Title - Sujet Additional Fridge & Freezer Space	
Solicitation No. - N° de l'invitation EZ899-162042/A	Amendment No. - N° modif. 003
Client Reference No. - N° de référence du client	Date 2016-02-19
GETS Reference No. - N° de référence de SEAG PW-\$PWY-025-7732	
File No. - N° de dossier PWY-5-38359 (025)	CCC No./N° CCC - FMS No./N° VME
Solicitation Closes - L'invitation prend fin at - à 02:00 PM on - le 2016-02-23	
F.O.B. - F.A.B. Plant-Usine: <input type="checkbox"/> Destination: <input checked="" type="checkbox"/> Other-Autre: <input type="checkbox"/>	
Address Enquiries to: - Adresser toutes questions à: Fung, Donna(PWY)	Buyer Id - Id de l'acheteur pwy025
Telephone No. - N° de téléphone (604) 666-9835 ()	FAX No. - N° de FAX (604) 775-6633
Destination - of Goods, Services, and Construction: Destination - des biens, services et construction: CSC - Matsqui Institution - Abbotsford, BC

This Amendment No. 003 is raised to incorporate Addendum #2.

Public Works and Government Services Canada Pacific Region	Travaux publics et Services gouvernementaux Canada Région du Pacifique	Drawing title: Titre du dessin: EXISTING FENCE RECONSTRUCTION DETAILS		designed by: conçu par: KH	
		scale: éche

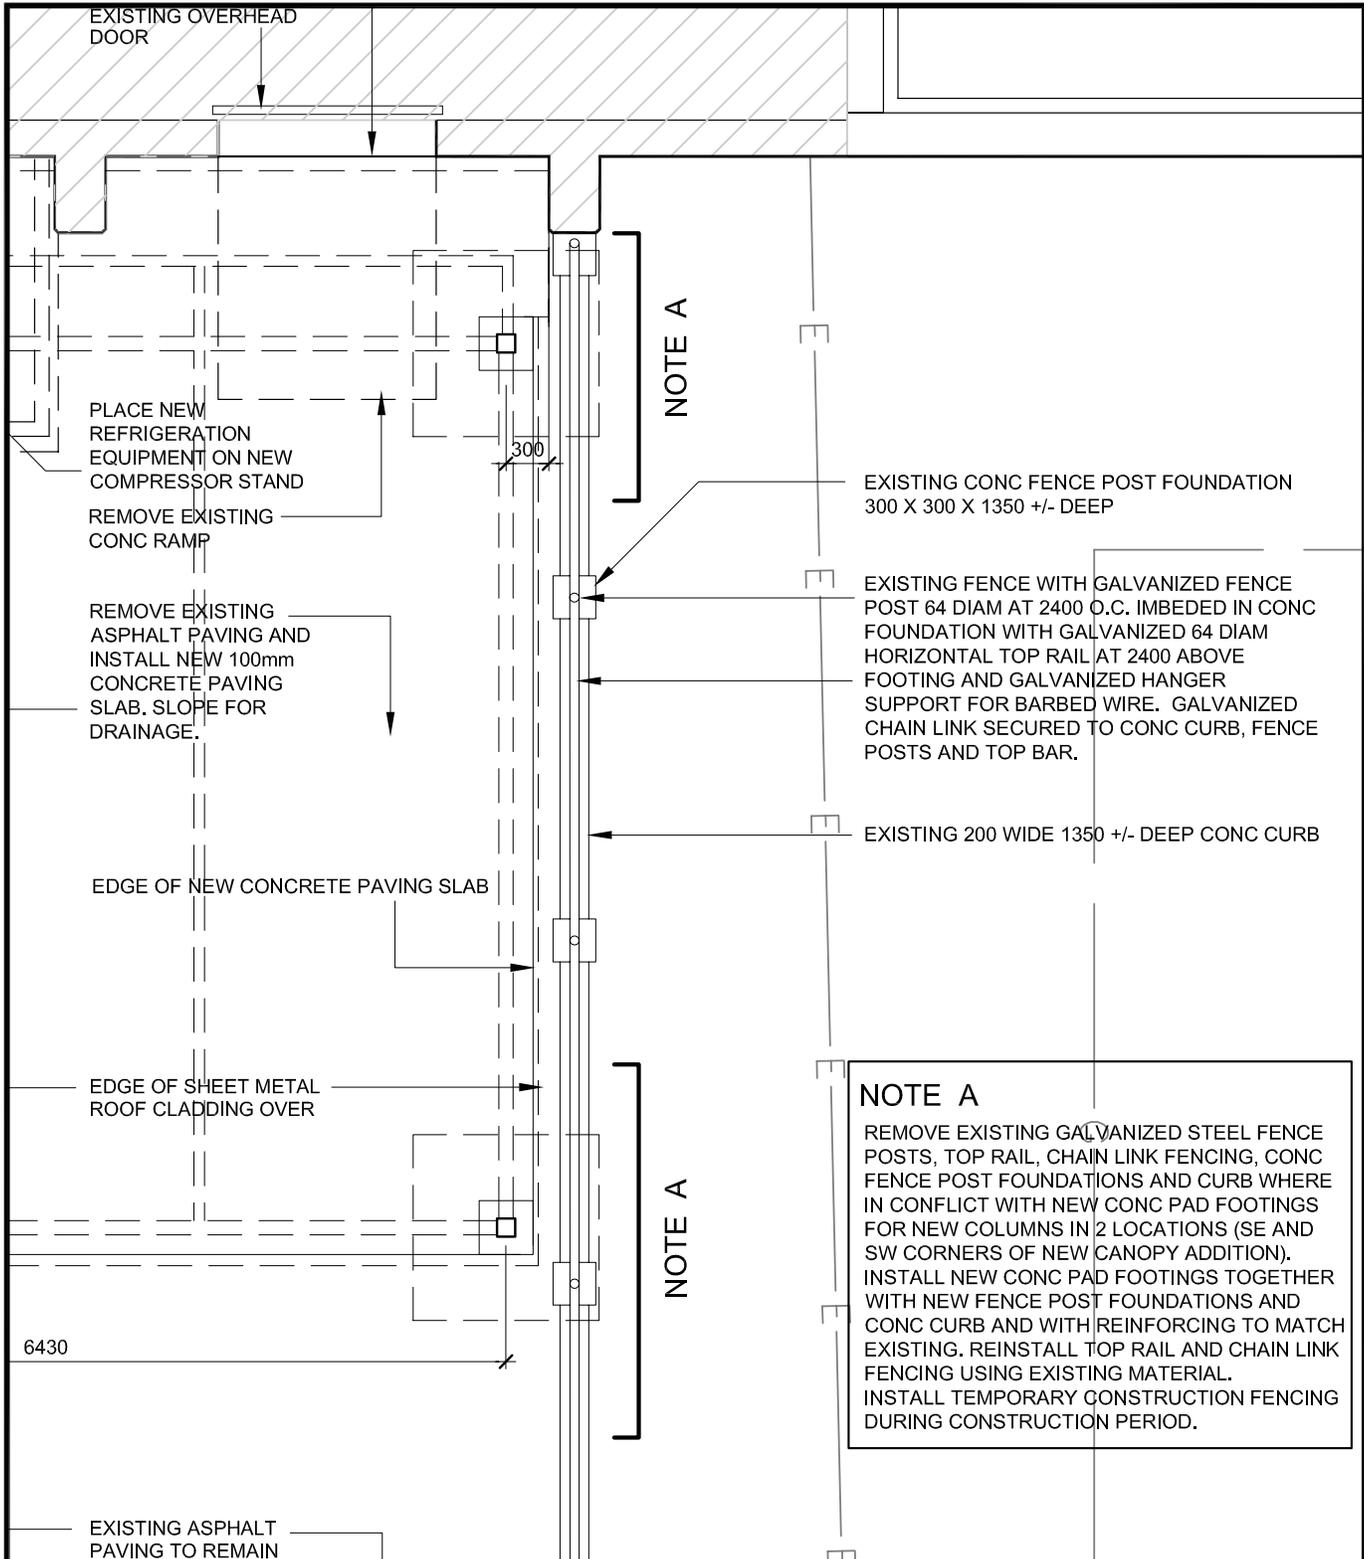
- .1 Provide temporary removal, demolition and reconstruction of portion of existing fence and footings immediately south of the new canopy addition and new concrete paving slab as described in Drawing ASK 01 attached.

REMOVE EXISTING GALVANIZED STEEL FENCE POSTS, TOP RAIL, CHAIN LINK FENCING, CONC FENCE POST FOUNDATIONS AND CURB WHERE IN CONFLICT WITH NEW CONC PAD FOOTINGS FOR NEW COLUMNS IN 2 LOCATIONS (SE AND SW CORNERS OF NEW CANOPY ADDITION). INSTALL NEW CONC PAD FOOTINGS TOGETHER WITH NEW FENCE POST FOUNDATIONS AND CONC CURB AND WITH REINFORCING TO MATCH EXISTING. REINSTALL TOP RAIL AND CHAIN LINK FENCING USING EXISTING MATERIAL. INSTALL TEMPORARY CONSTRUCTION FENCING DURING CONSTRUCTION PERIOD.
